CSI Action Sheet

Application for Assessment of a Site Investigation Report

SUITABILITY STATEMENT

**Re: Draft Site Management Plan
Lot: 1 Plan: M 356134
Former Mobil Depot
27 Reynolds Rd, Mareeba Qld**

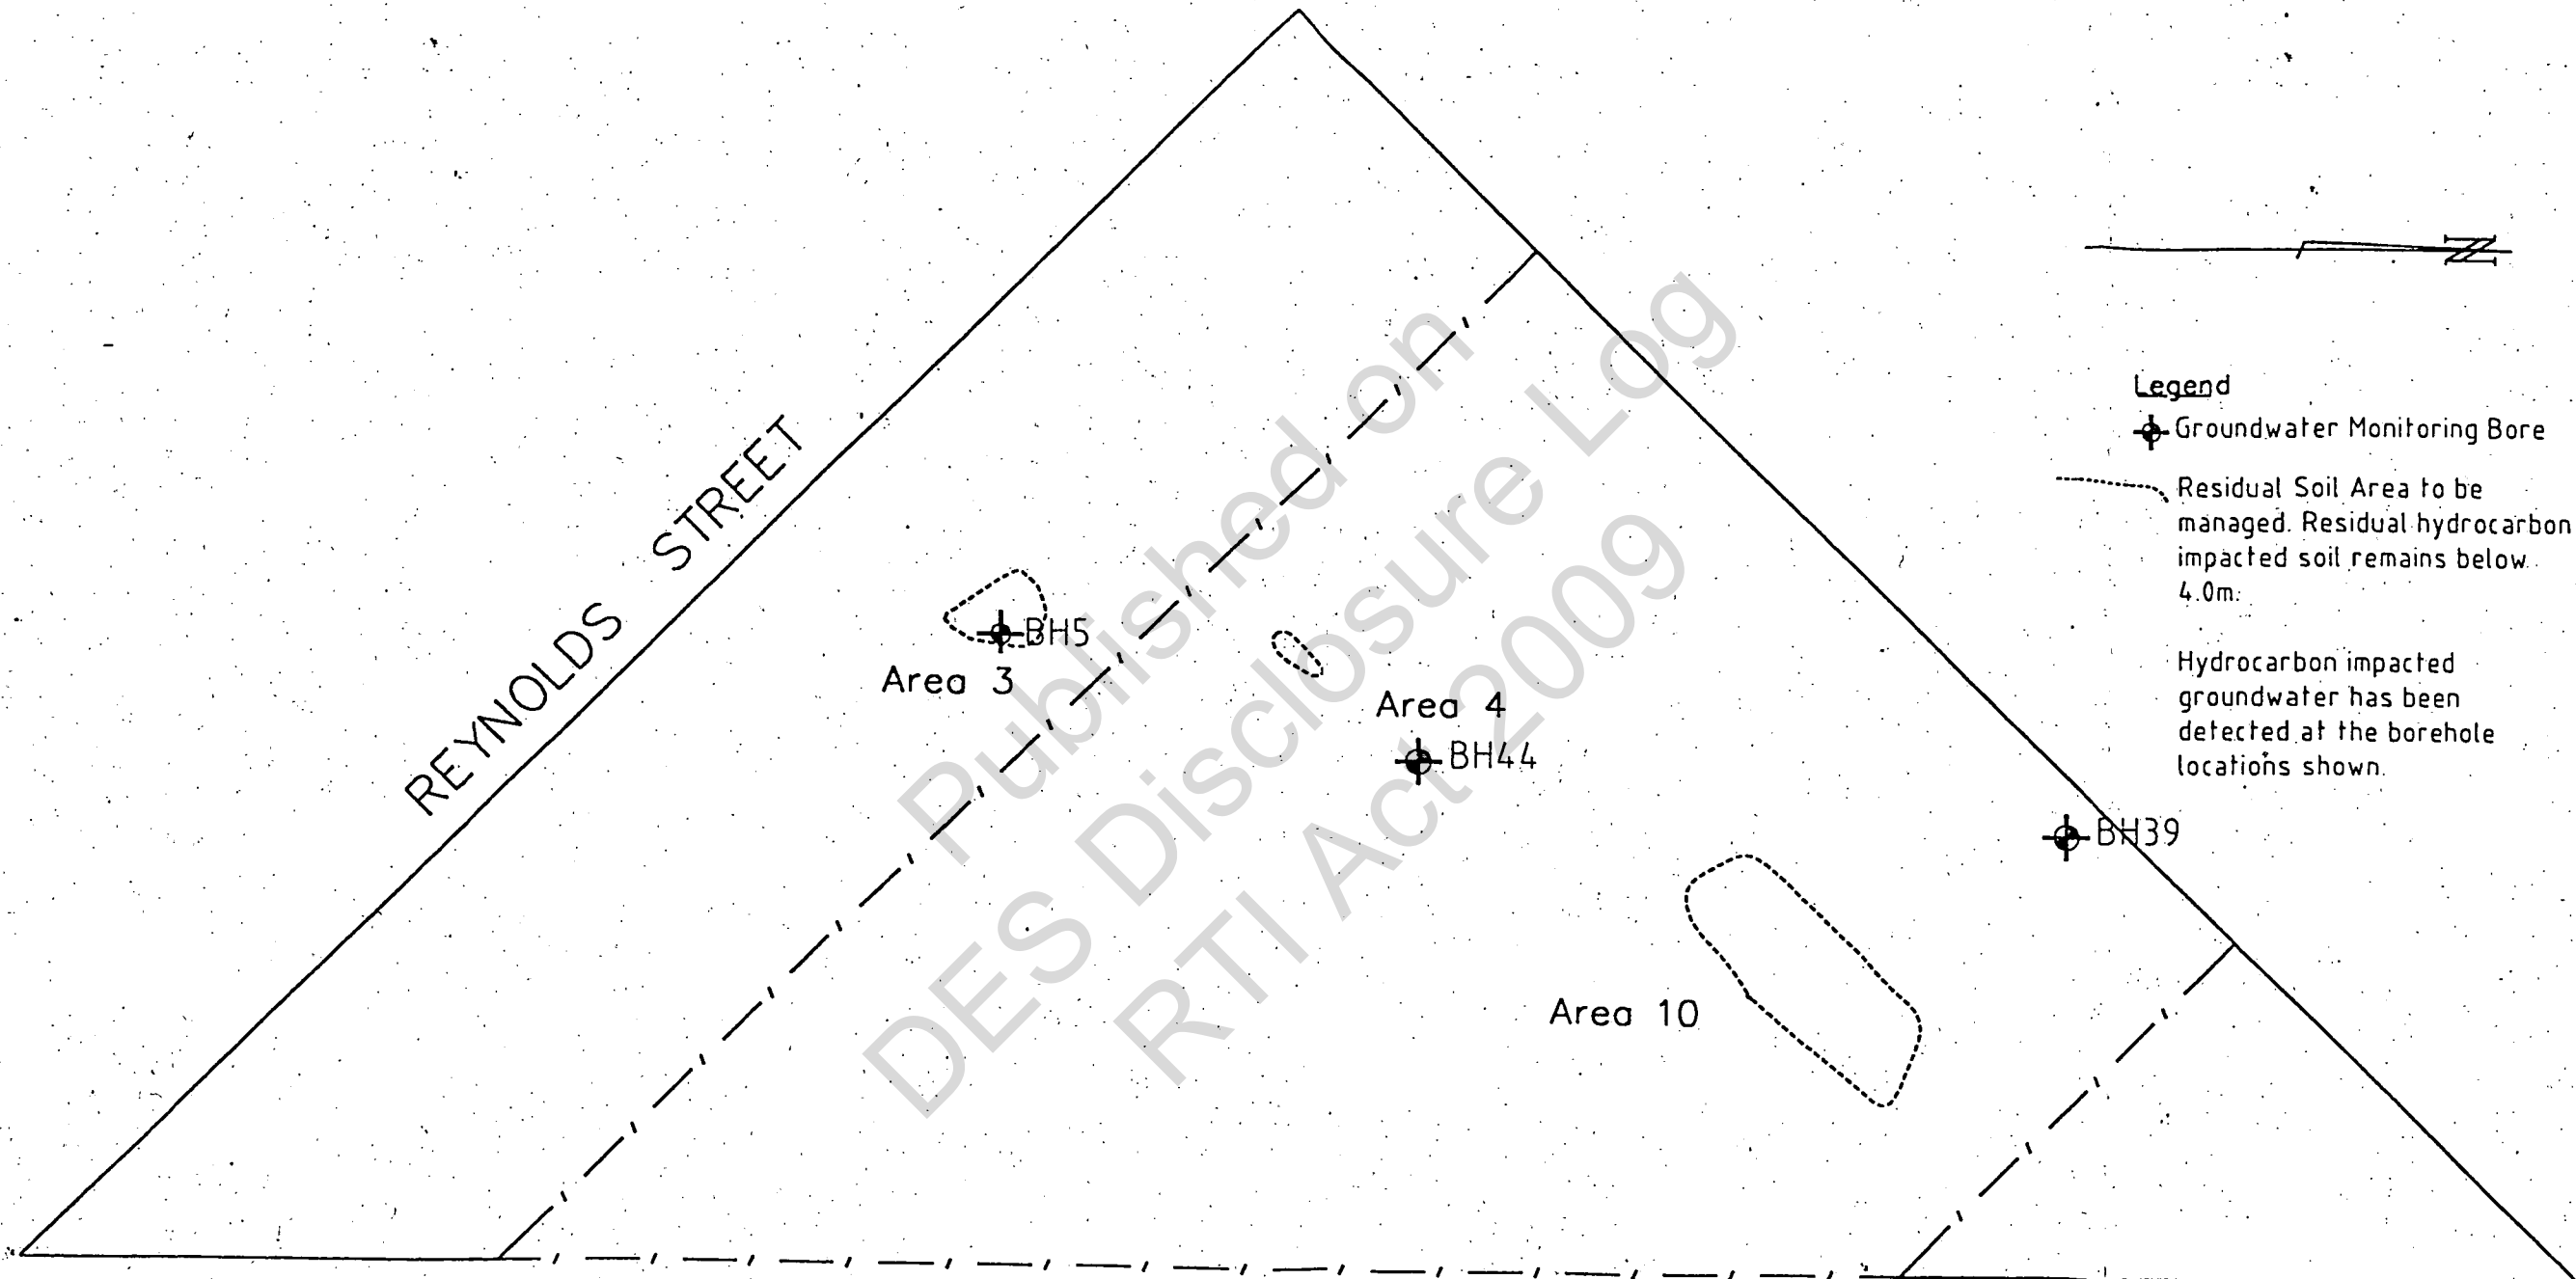
Please find attached a revised draft Site Management Plan (SMP) attachment and diagram for the Lot referenced above. The Environmental Protection Agency (EPA) has reviewed the conditions of the SMP and require that these conditions be approved by the owner of the lot and any proposed purchaser, if the site is scheduled for sale and a buyer/developer has entered into a contract.

CLIENT Mobil Oil Australia Pty Ltd		PROJECT Depot - Reynolds St, Mareeba (PM01)	
	DRAWN LMC	DATE 06-08-01	TITLE RESIDUAL SOIL CONTAMINATION LOCATIONS	
	CHECKED sch4p4(6) Personal information	DATE 8/8/01	PROJECT No 00673025	
	SCALE 1:400	A3	FIGURE No 1

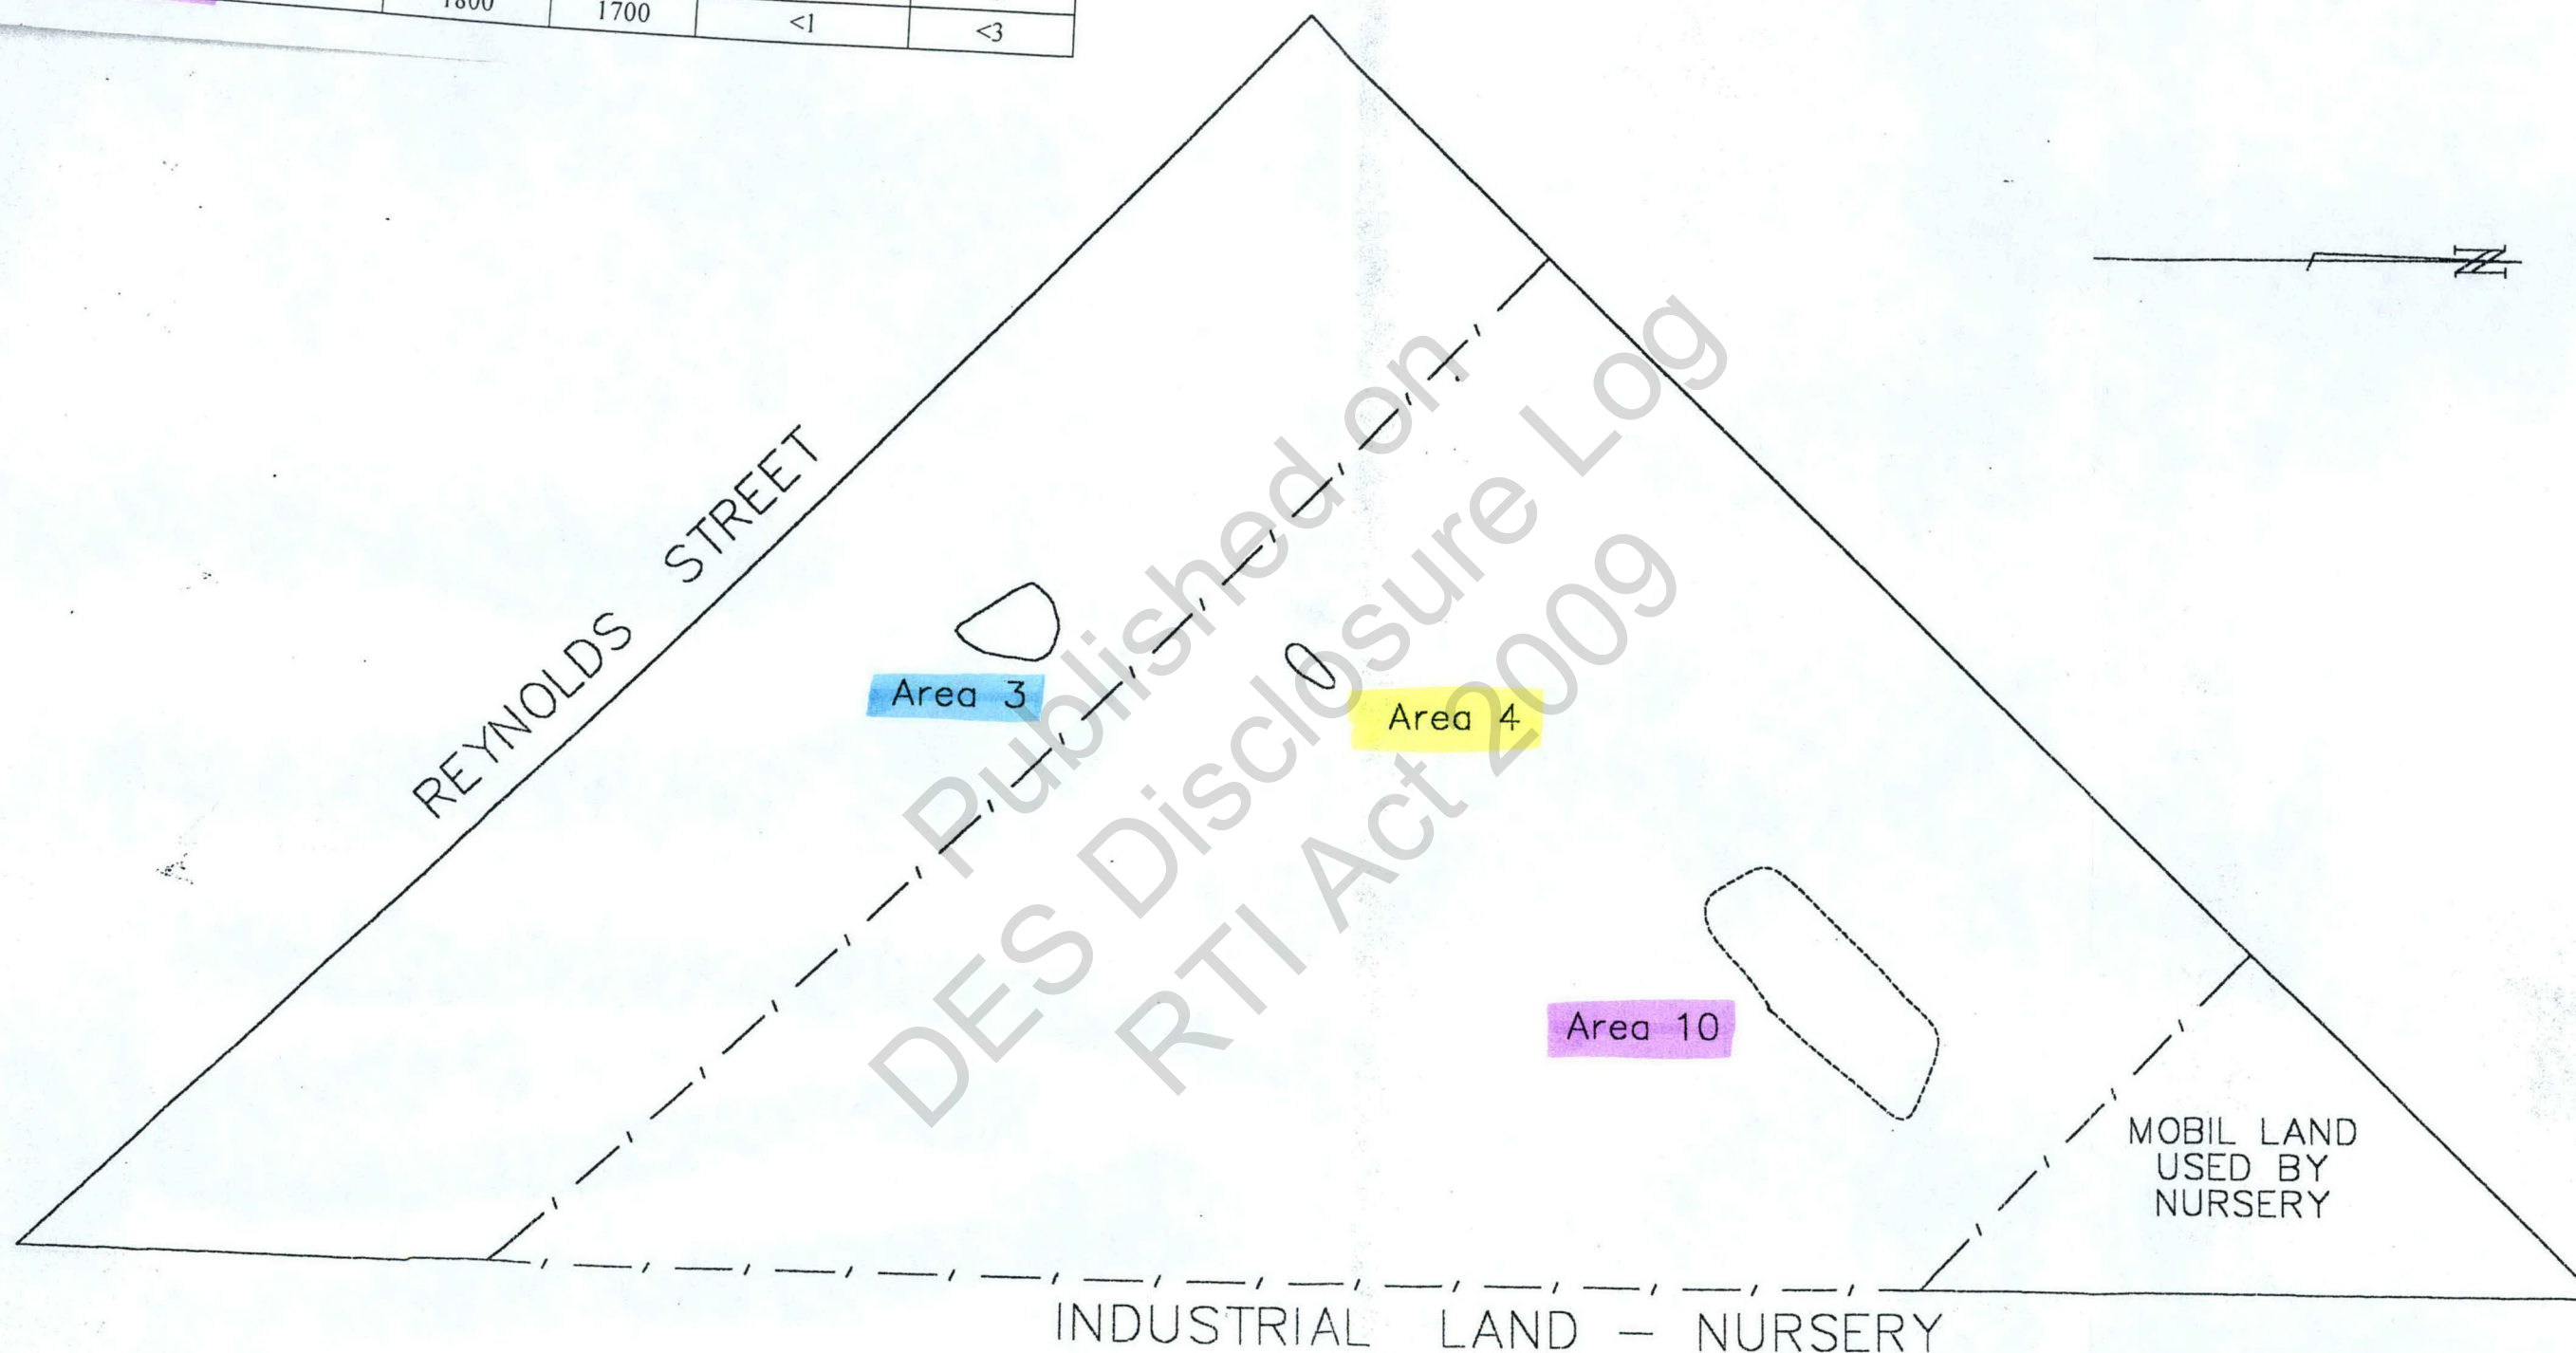
09/10/2001 BNE1230	Anita Packwood Suhle Street, Mareeba	Petroleum Product or Oil Storage Lot 1 M 356134	Mobil Oil Australia Pty Ltd
Goal: Removal from the EMR.			
<u>Background Information:</u> <ul style="list-style-type: none"> * The geological structure of the area was identified as red brown basaltic clays to depth varying between 1.5m at the northern end of the site to greater than 4m in the southern. The area is underlain by remnant flows of olivine basalt of the Atherton Basalt Formation. * Impacted material was removed across the site to a minimum of 4m. Figure 1 shows areas where residual contamination remains and the table on Figure 1 shows the maximum levels remaining. * Groundwater - The site is not located in a proclaimed area. DNR information states that bore yield in the Mareeba area is generally <1L/s. Potable use of the groundwater would be rare. Groundwater beneath the site is expected to be 15m - 20m below ground surface. Groundwater flow direction is expected to be north east as per regional drainage lines. * Groundwater has been used by the neighbouring nursery for 24 years with no adverse effects seen to date. 4 bores were sampled in the groundwater monitoring. 3 on-site and the nursery bore. The on-site wells are believed to be located in a perched water table as the standing water levels were between 6.25m and 6.5m. * No phase separation was noted in any samples taken. Maximum TPH levels found in the ground water samples are shown in the table on Figure 2.

<u>Recommendation:</u> <ul style="list-style-type: none"> ❖ Disagree that contamination below 4m can be disregarded and that the levels of contaminants found in the groundwater do not pose a possible risk to human health or the environment as it is noted that the Risk Assessment scenarios have been designed for off-site not on-site use. Scenarios should be carried out for an in-site bore and its use. ❖ Recommend that an additional information letter be sent to the consultant and owner stating that as contamination remains on site, the site will remain on the register. Suggest that the consultant undertake a further Risk Assessment analysis based on the on-site use of groundwater from a bore.
